Final
Environmental Impact Statement
for

Cyprus Miami Leach
Facility Expansion Project
Miami, Arizona

**FINAL
ENVIRONMENTAL IMPACT STATEMENT
CYPRUS MIAMI MINING CORPORATION
LEACH FACILITIES EXPANSION**

The Final Environmental Impact Statement (FEIS) provides responses to comments received by Bureau of Land Management and Forest Service during the public comment period on the Draft EIS (DEIS). The DEIS analyzed impacts that may occur from the proposed new facilities to support the continuation of the copper mining operations at Cyprus Miami Mining Corporation's mine in Miami, Arizona. The proposed action includes: 1) constructing three new leach facilities and 2) constructing a new waste rock disposal area each located on a combination of private land and lands administered by both the BLM and Forest Service. Three alternatives were analyzed in detail in the DEIS: The Proposed Action, Alternative A - Modified Development Sequence and the No Action alternative. The Proposed Action and Modified Development Sequence Alternatives would extend the life of the mine from 16 to 20 years, with final closure around 2021. Total land disturbance associated with the two action alternatives is

Figure 1-1
COMPARISON OF ALTERNATIVES FOR

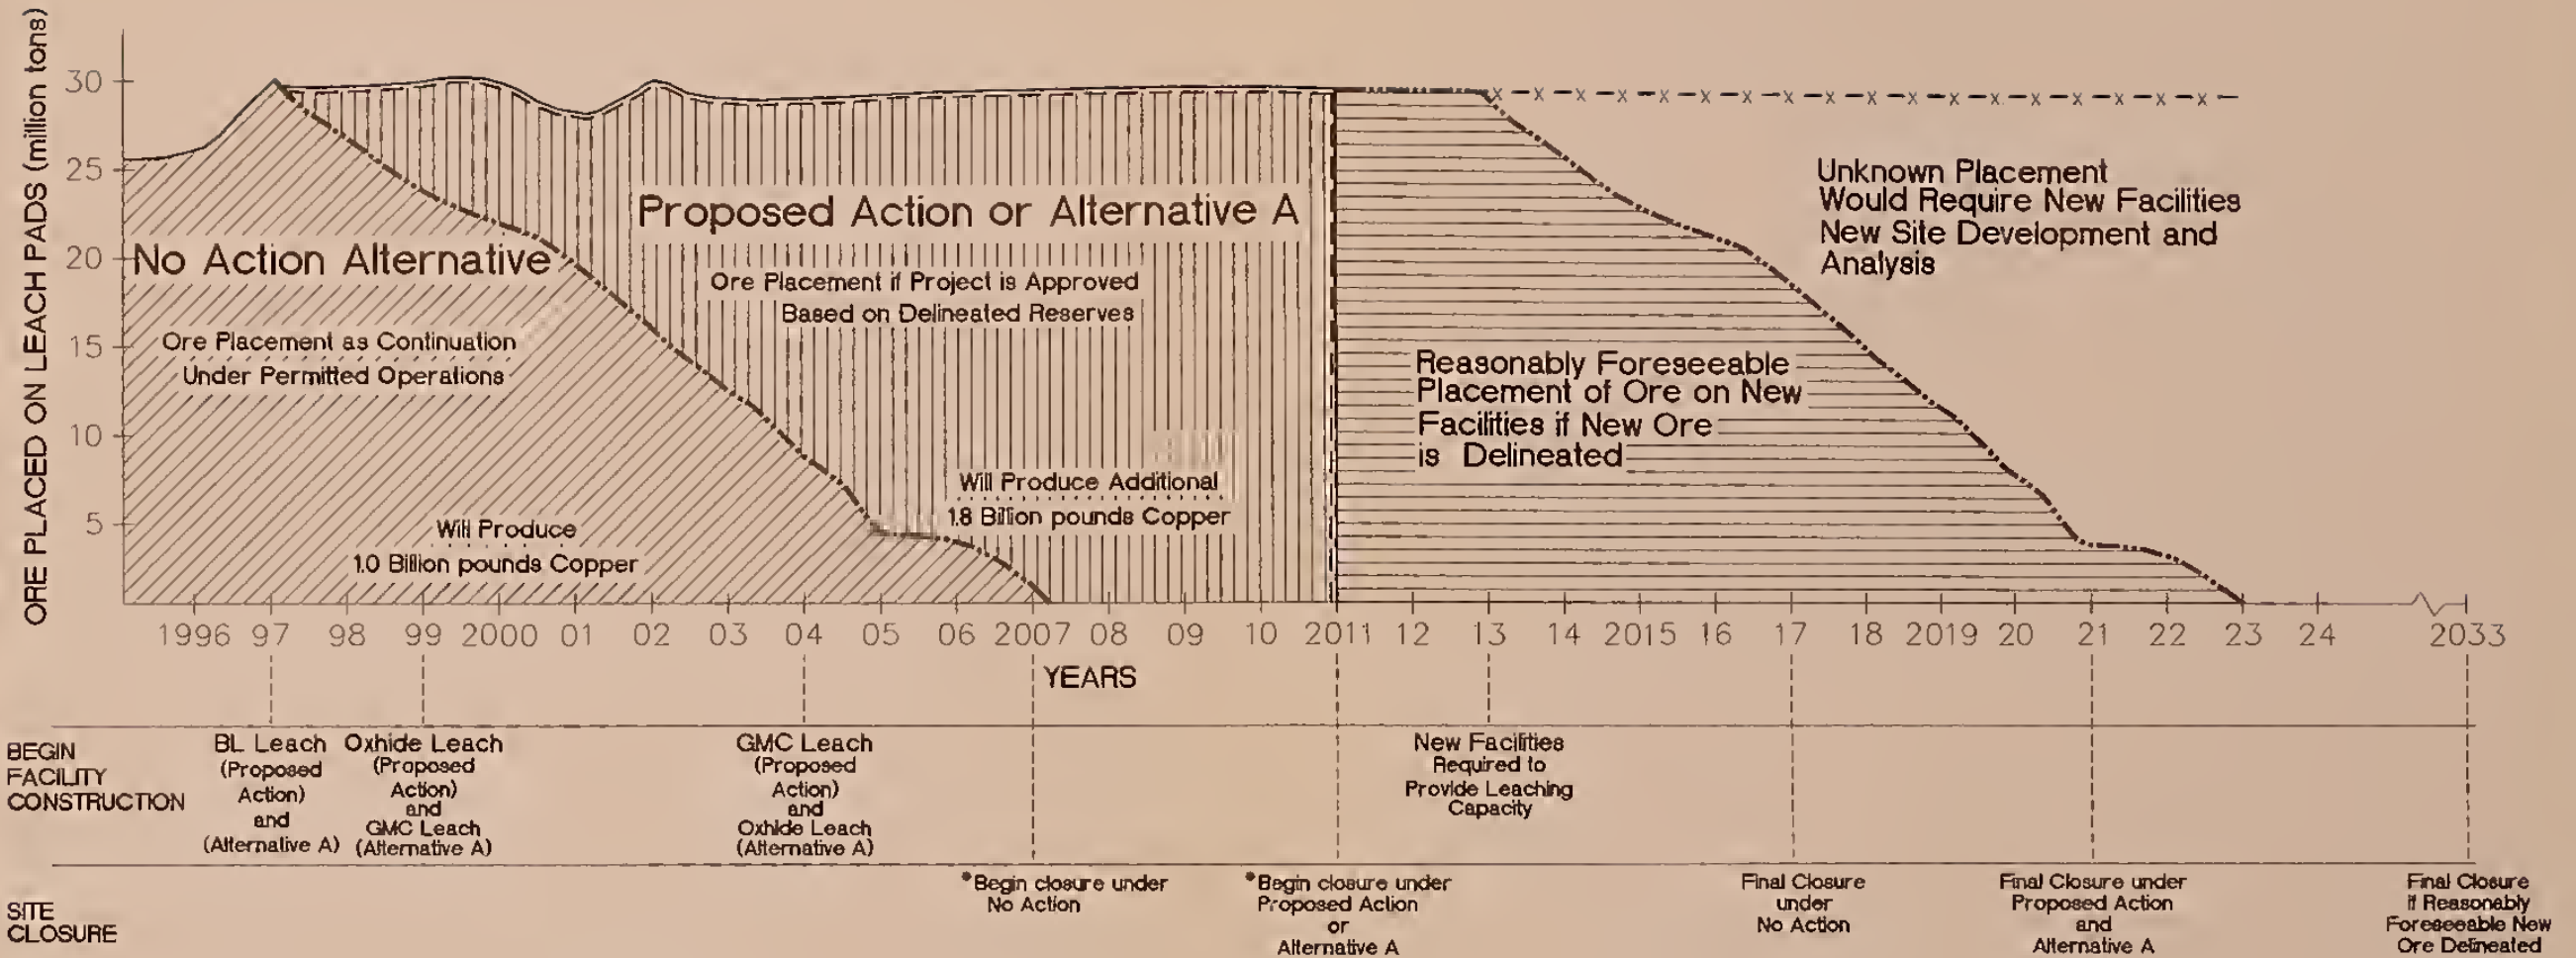
- 39n. Figure 1-1 on page 1-5 of this FEIS presents a reasonably foreseeable projection of mine activity. Actual locations for mine expansion are much more speculative. If Cyprus Miami proposes to utilize additional public lands in the future, it will have to submit a Plan of Operations to the Federal land management agency.

Figure 2-4

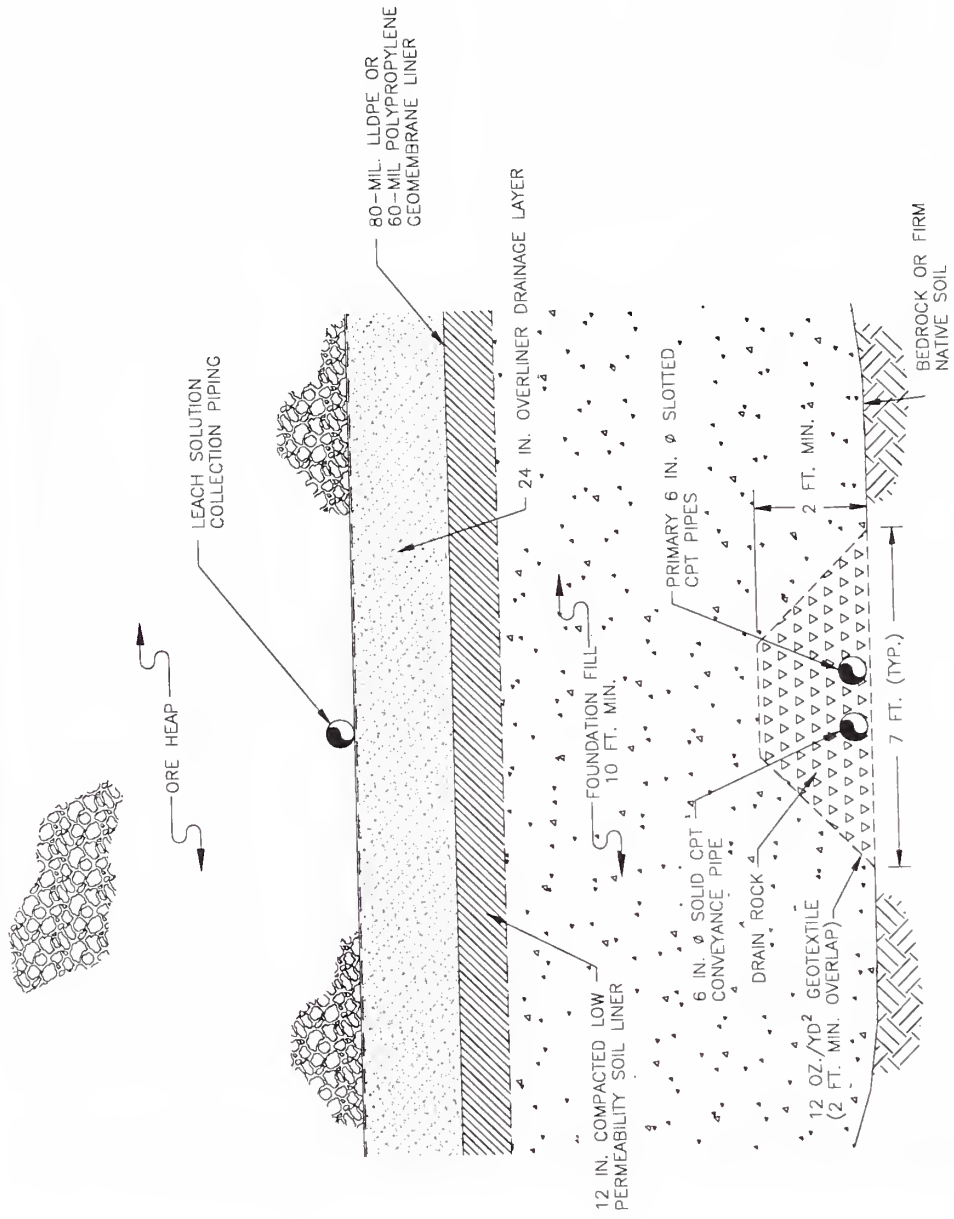
The 4th paragraph of this section would then begin "The specific methods of....."
- Page 2-10 Additional information has been added to Figure 2-4, and the figure is reproduced later in this chapter.
- Page 2-11 Section 2.4.2.2, 1st bullet: Insert "or suitable soil" after "tailings".

Page 2-10
Figure 2-4

Figure 2-6

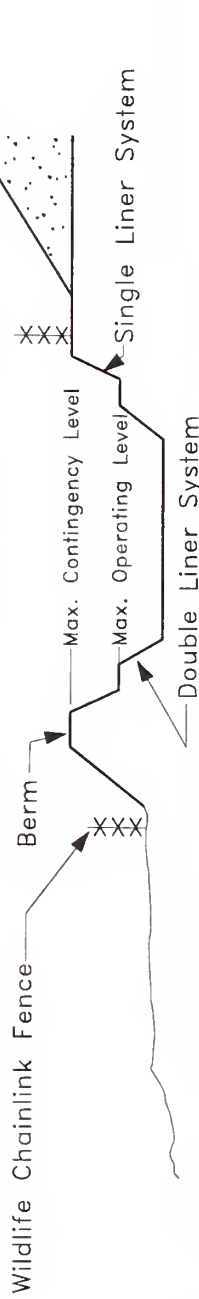
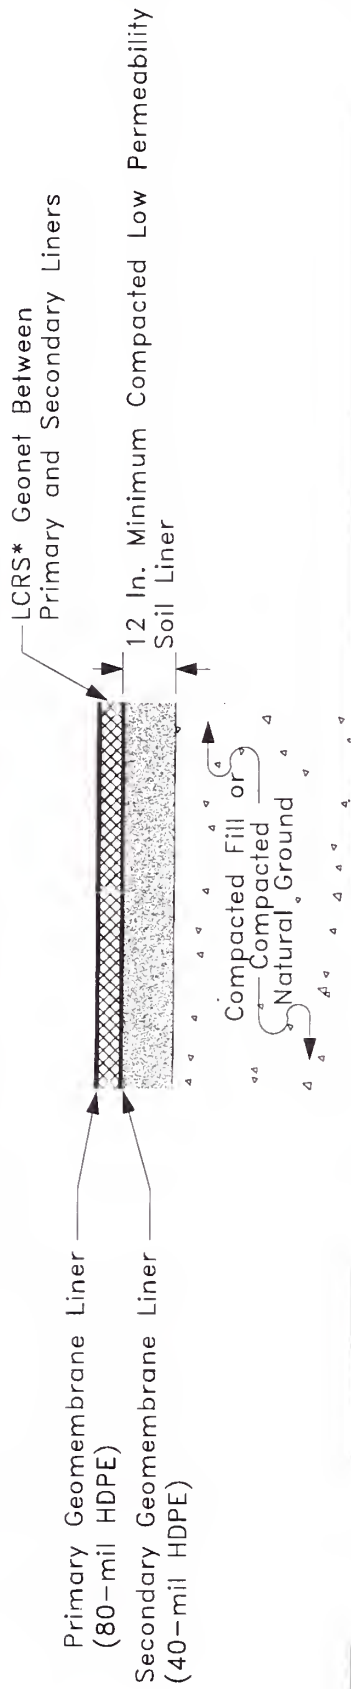
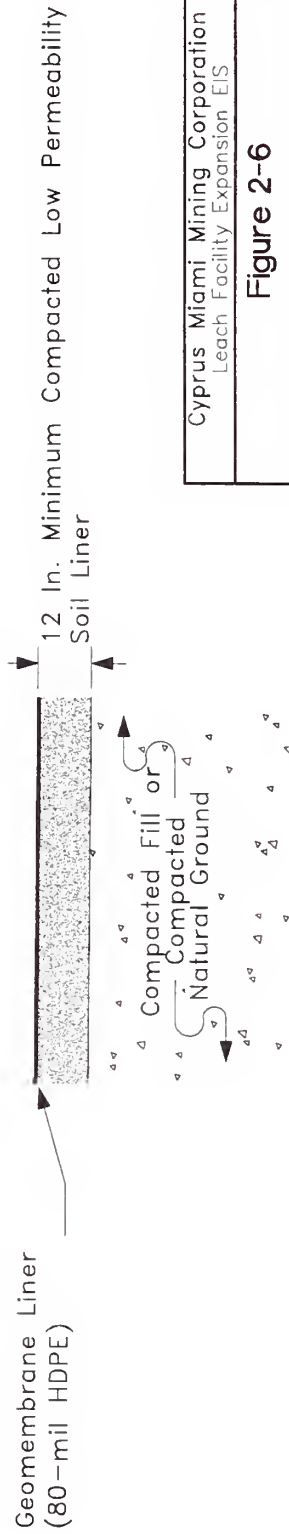
- Page 2-14 Additional information has been added to Figure 2-6, and the figure is reproduced later in this chapter.
- Page 2-15 Section 2.4.2.8: Change "1993" to "1996".

33f. These changes have been made. Figure 2-6 is presented on page 2-14 of this FEIS.
